Subject: FCC ID#AAO4300732

FCC ID: AAO4300732
Applicant: RadioShack A division of Tandy Corporation
Reference # 9664
Confirmation# EA95034

There are difference between old RF Module and new RF Module.

(OLD RF MODULE)

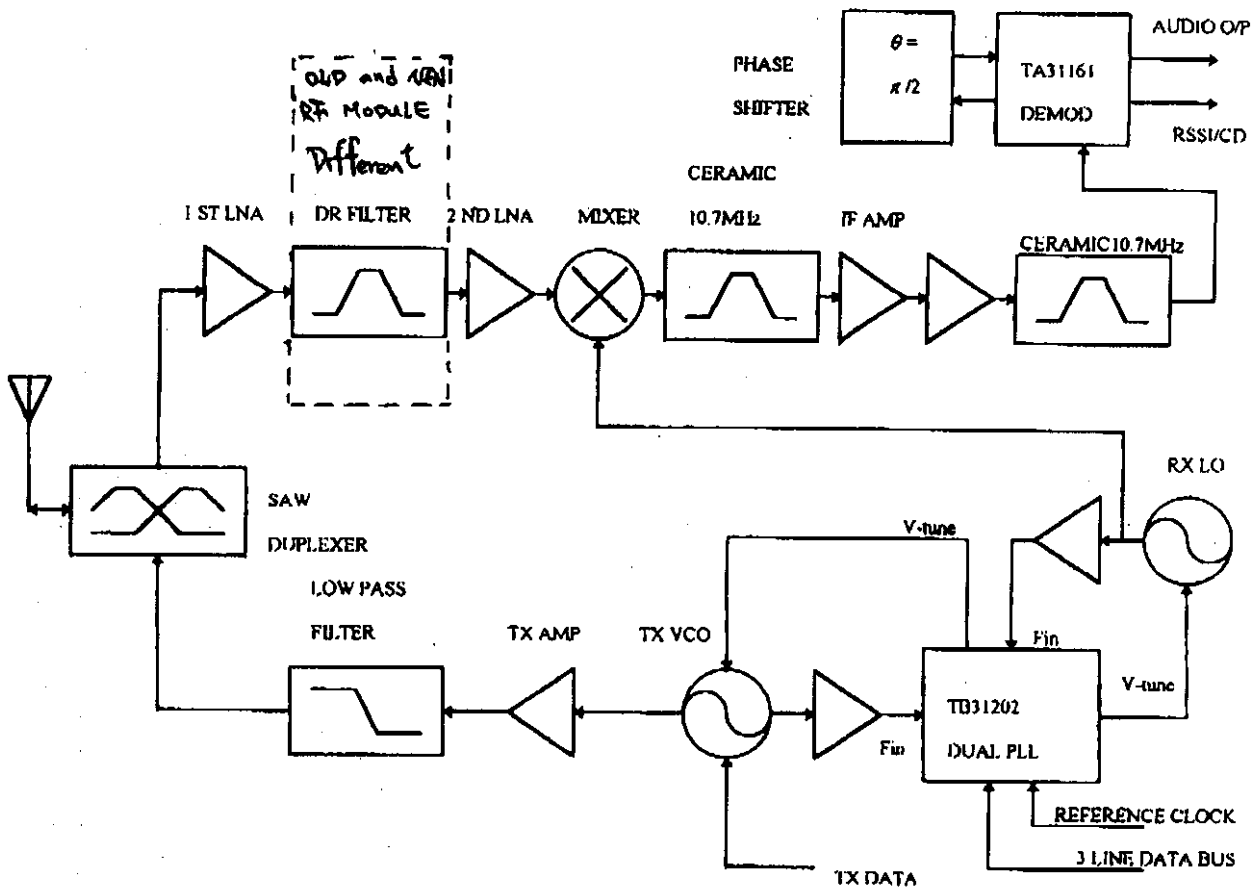
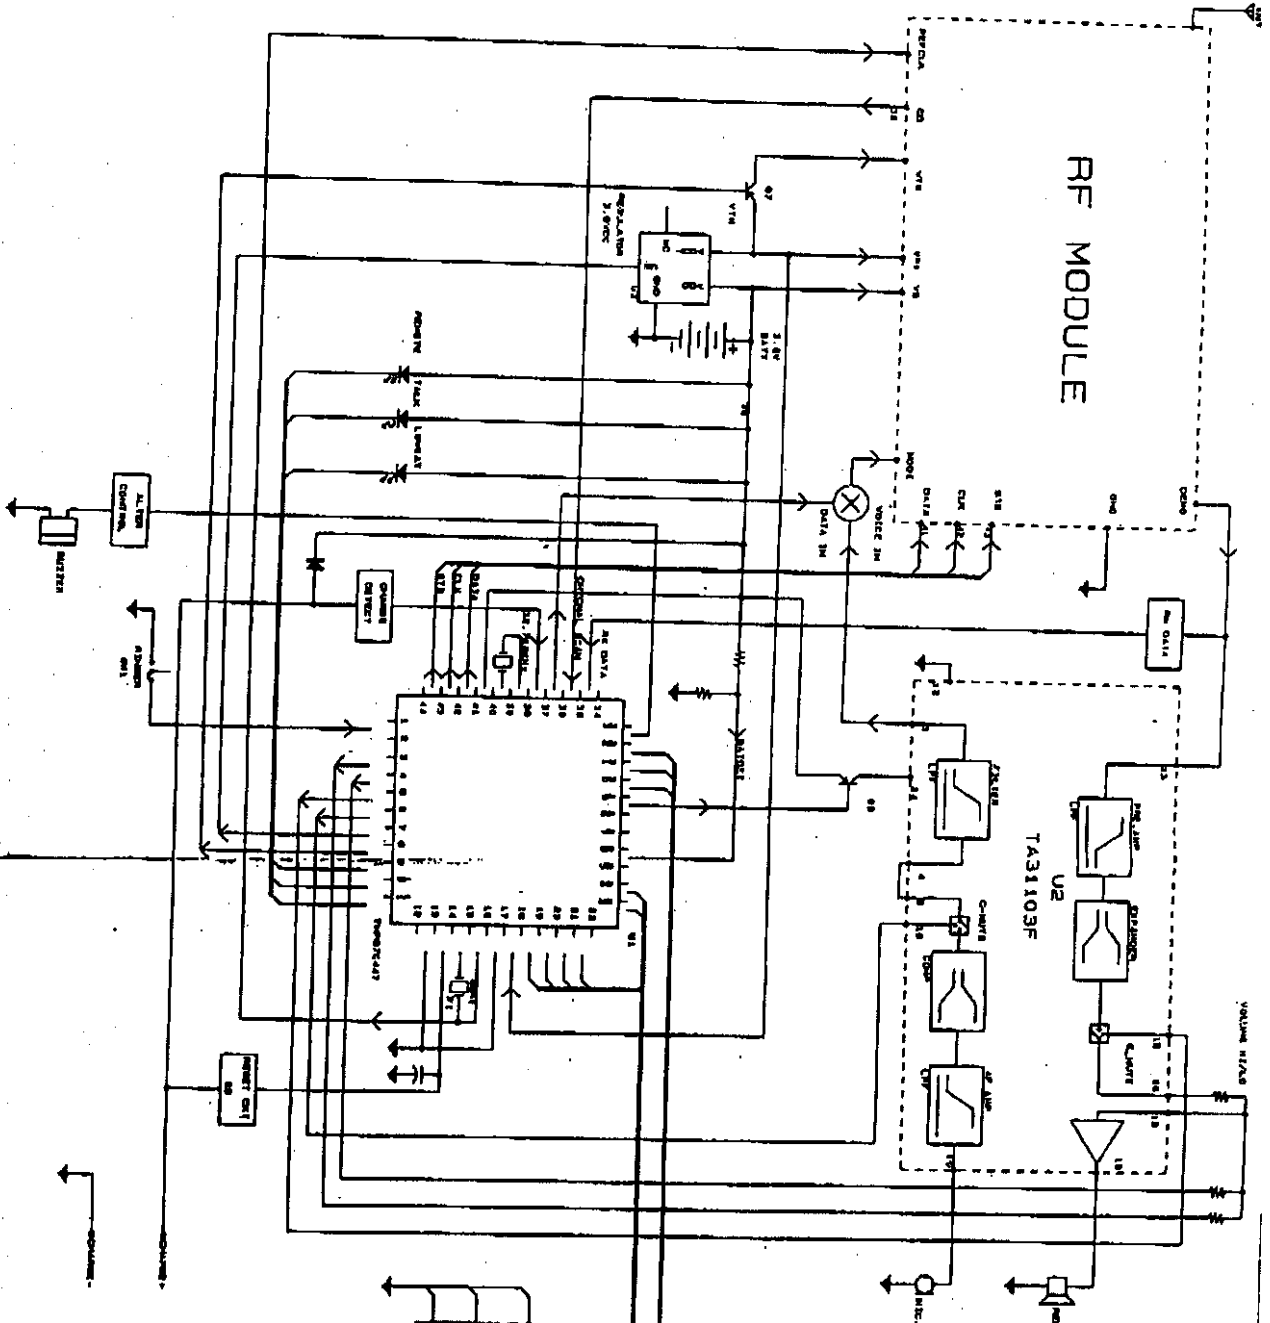
SAW FILTER. 使用 ≡ 家 廠商

- 4/3:
1. DUPLEXER SAW FILTER B4009 ⇒ SIEMENS
 2. DUPLEXER SAW FILTER B4029 ⇒ SIEMENS
 3. DUPLEXER SAW FILTER X0324C ⇒ SAM SANG

- B/3:
1. DUPLEXER SAW FILTER B4008 ⇒ SIEMENS
 2. DUPLEXER SAW FILTER B4078 ⇒ SIEMENS
 3. DUPLEXER SAW FILTER X032BC ⇒ SAM SANG

New RF module (Base)

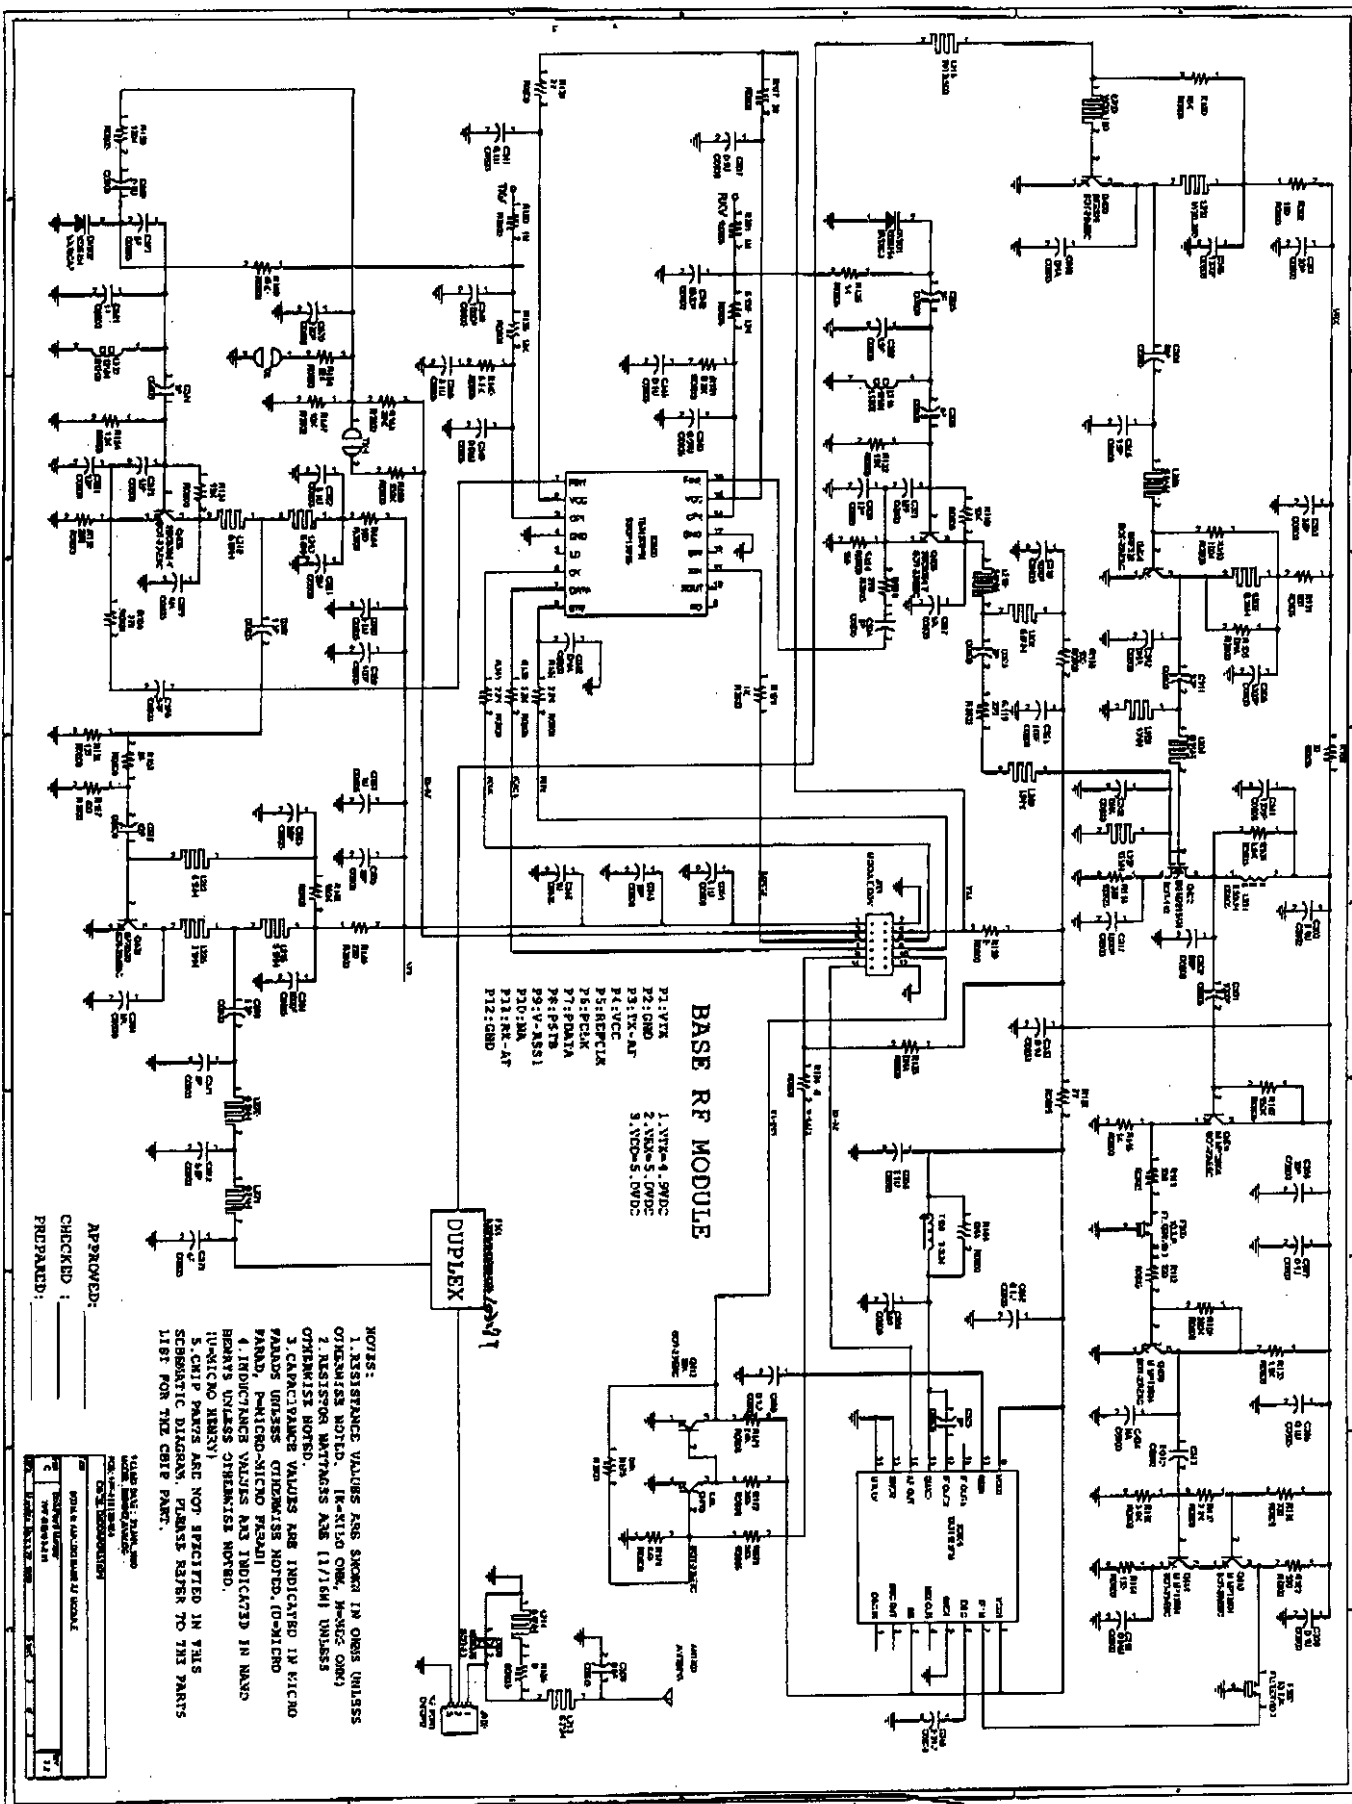
New RF Module:

1. No DR Filter
2. It has second source for saw filter.

Base : Duplexer saw filter
Manufacturer: KEC
Model# 0327T
